Heater Water Valve – Knocking Noise
During Climate Control Operation –
Repair Procedure

MODEL 1995 MY
Sedan Range
VIN
720001 - 739750

ILLUSTRATION 1

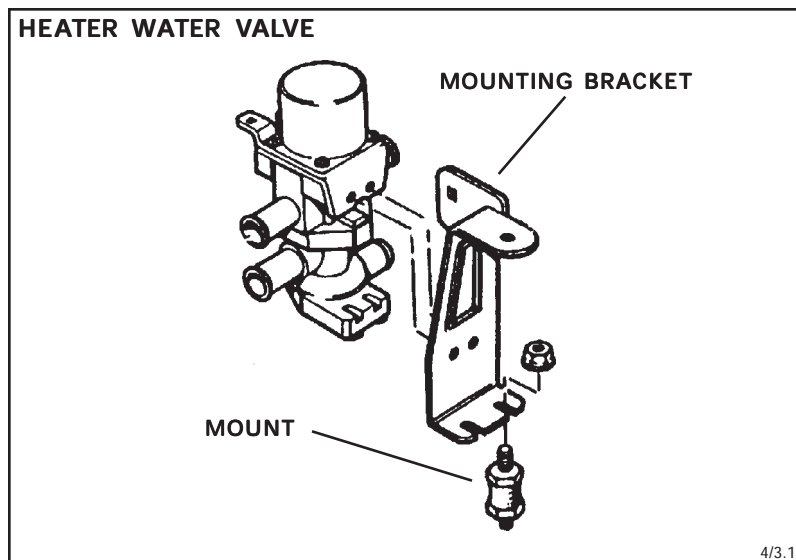
1. Remove the heater valve and mounting bracket assembly from its three mounts (Illustration 1).
2. Remove the three existing heater valve mounts (“Instrumounts”). Replace the mounts with three new mounts (part number MNA 6730AB).
